DPO Case File for DPO-2013-002

The following pdf represents a collection of documents associated with the submittal and disposition of a differing professional opinion (DPO) from an NRC employee involving seismic issues at Diablo Canyon.

Differing Professional Opinion – Diablo Canyon Seismic Issues

Figure 1, Comparison of the DDE/SSE and the HE Floor Response Spectrum, Containment Elevation 88'

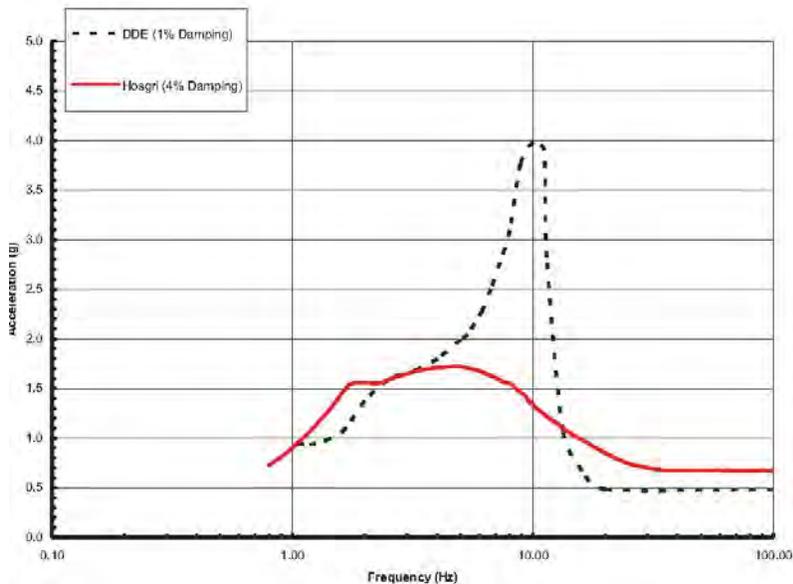
Figure 1 illustrates the results of the different methods and assumptions use in DDE/SSE safety analysis and the HE. This figure compares acceleration levels (shaking) in the reactor containment building.

Plant SSCs are most affected in the 3 to 8.5 Hz frequency range.

Note that the level of "shaking" is significantly greater for the SSE/DDE than for the HE at this plant location. This may seem counterintuitive since the HE is a much larger earthquake. However, as this figure illustrates, comparing ground motion alone is not sufficient to evaluate seismic qualification. Methods, assumptions, initial conditions, and acceptance criteria used in the analyses are just as important as ground motion.

The qualification process used information, such as shown in Figure 1, to establish the amount of seismic stress SSCs may be exposed to during the SSE. A component located at this location would be qualified for the SSE/DDE. If the SSC was also credited for HE safe shutdown, no additional qualification would be required. At this plant location, the seismic stress is dominated by the SSE/DDE. Qualification to the SSE/DDE would envelope the seismic stress generated by the HE.

Figure 2
 HE Maximum CRDM Bending Moments¹⁷

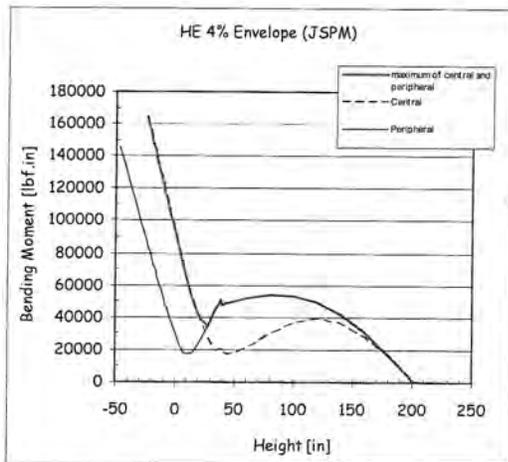
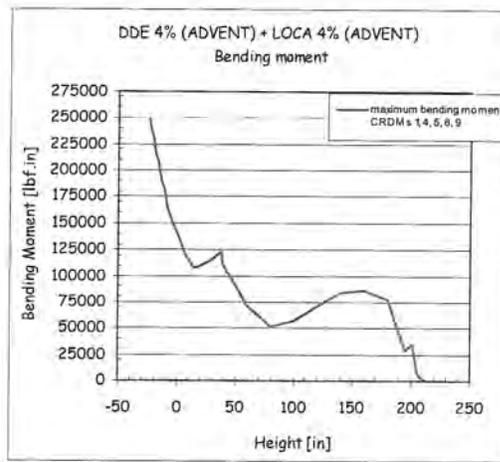
The Code methodology adds seismic loading, generated by either the SSE/DDE safety analysis or the HE, to other non-seismic loads affecting the component. The resulting SSE/DDE stress is significantly greater than for the HE in many loading cases. Again, this may sound counterintuitive since the HE is based on a much larger earthquake. These differences in component stress reflect the differences in the methods, assumptions, load combinations, and initial conditions used in each seismic analysis. For example, Figures 2 and 3 compare the Code bending moments calculated for the control rod drive mechanisms used to support the replacement reactor head modification. As seen in these figures, the bending moments (seismic stress) were much greater for SSE/DDE case than for the HE.

Figure 4
Comparison of the DDE/SSE and the HE Floor Response Spectrum, Containment Elevation 88'

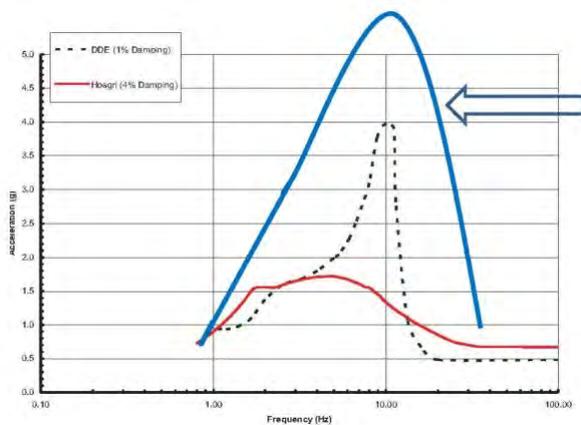
A comparison of the new seismic information against the existing SSE/DDE safety analysis would yield seismic stress greater than the values used during the original SSC qualification. However, in many cases, the actual SSC qualification tests were performed at higher levels than required to meet the design basis. These higher qualification levels provide engineering margin that may be recovered for “operability.”

Figure 2. Response spectra for Diablo Canyon NPP containment building and other structures, from FSARU figures indicated in legend.

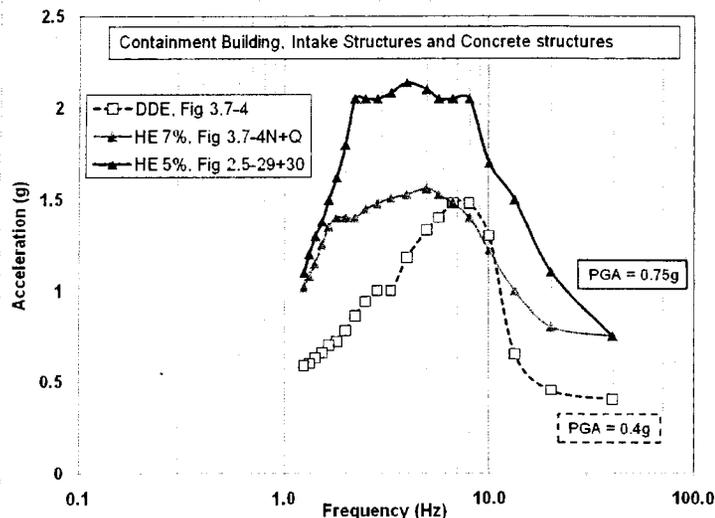
Figure 2 illustrates the importance of these differences in analytical methods and assumptions. Analyses of seismic loads on the Diablo Canyon containment building used 5% damped, *free-field* ground motions for the DDE. However, the HE analyses used 7% damped, *foundation-filtered* ground motions, which are approximately 10% lower than the DDE ground motions for 7–10 Hz frequencies. Load calculations on the containment building are sensitive to this frequency range. Consequently, these different methods and assumptions result in the DDE creating higher calculated loads on the containment building than the HE. For some other important structures, systems, and

discussed in the background information (see Figure 2), some SSC analyses used ground motions for the Hosgri evaluation that were effectively lower than DDE ground motions. This situation occurs because most safety analyses were done with ground motions that were different than the 5% damped free-field reference condition.

Returning to the containment building example from Figure 2, seismic loads for the Hosgri evaluation were represented by a 7% damped, foundation-filtered ground motion. In contrast, DDE seismic loads in these analyses were calculated with a 5% damped, free-field ground

motion. Thus, the DDE created the highest accelerations (i.e., structural loads) at spectral frequencies of 7 to 11 Hz. If these DDE and HE ground motions were inappropriately compared to the new ground motions shown in the 2011 Shoreline report (Figure 4), it would appear that the new ground motions might exceed the levels previously considered in the FSARU for frequencies of 5 to 30 Hz. Nevertheless, the assumed validity of this incorrect comparison is a fundamental assumption for the logic in the DPO submittal regarding the need for additional actions by both PG&E and NRC.

Figure 3 Ground motions from indicated figures in FSARU (DDE, HE), Long-term seismic program (LTSP), and 2011 PG&E Shoreline report (ergodic method).

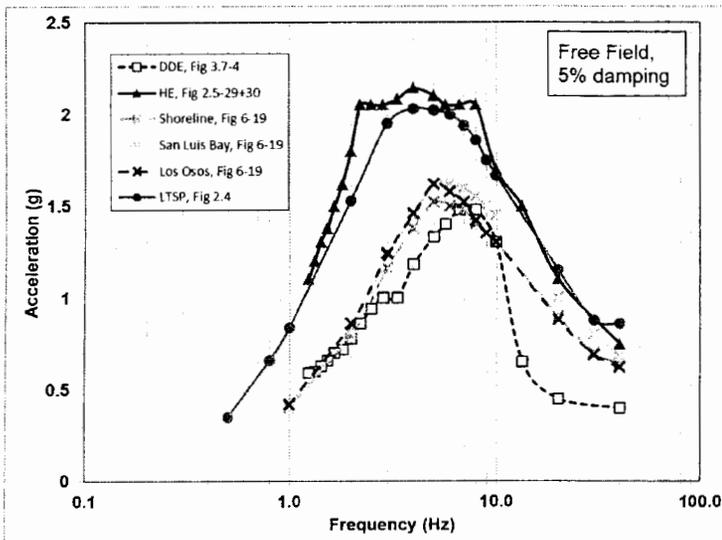
For this concern, the Panel determined that the evaluations to-date may not have fully considered the potential significance of the new ground motions on the existing FSARU licensing basis for Diablo Canyon. The DPO submitter identifies some shortcomings in previous evaluations, but also makes incorrect comparisons between the new information and information in the FSARU to reach a conclusion about operability and appropriate licensee and NRC actions. The incorrect comparisons appeared to have occurred, however, because PG&E provided insufficient information in the 2011 Shoreline report to appropriately compare the new ground motions to the range of ground motions actually used in the seismic analyses described in the FSARU. Thus, additional information was needed by NRC, PG&E, and the DPO submitter to make correct comparisons.

In the 2011 Shoreline report, PG&E develops new ground motions for the Shoreline, Hosgri, San Luis Bay, and Los Osos faults and compares these ground motions to the original Hosgri evaluation and the Long-Term Seismic Program. This comparison only evaluates results for a standard reference condition, which is a free-field ground motion with 5% damping (Figure 3). As shown in Figure 3, if the original Hosgri evaluation represented the largest ground motions actually considered in the design and qualification of SSCs, then the newer ground motions would clearly be lower than already considered in the original FSARU licensing basis. However, as

The remainder of this DPO concern focuses on the same issue of ground-motion comparability that was discussed for DPO Concern #1. As shown in Figure 3, potential ground motions for the Los Osos and San Luis Bay faults can be approximately 10% higher than potential ground motions for the Shoreline fault. Ground motions for these three faults were all calculated with the same methods and assumptions. Thus, equivalent changes in the amount of damping or presence of building foundations should have equivalent changes in the calculated ground motions. In other words, the relative relationships between these three ground motion response spectra should not change significantly. Nevertheless, the Los Osos and San Luis Bay potential ground motions shown in Figure 3 have the same limitation as the Shoreline potential ground motions, in that they are not directly comparable to the full range of ground motions used in the FSARU to license Diablo Canyon. As discussed in Concern #1, these faults were considered explicitly in the March 2014 supplemental analyses by PG&E. The reanalyzed ground motions for the Los Osos and San Luis Bay (and the Shoreline) faults do not exceed the level of ground motion already used to design and license the plant.

Figure 4. Ground motions from FSARU and 2011 Shoreline Report figures (ergodic method), incorrectly assuming the new ground motions are directly comparable to FSARU inputs for containment building analyses.

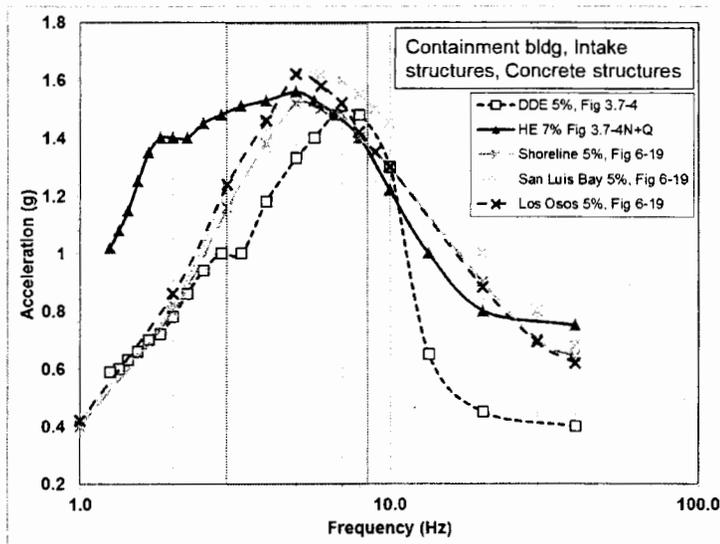
such as the presence of building foundations or non-linear material responses (e.g., FSARU rev 21, section 2.5.3.10), should be considered for the new ground motions. These considerations are not expressed in the 2011 Shoreline report, or in staff's previous evaluations of the issues surrounding the Shoreline Fault ground motions, or in the DPO submittal.
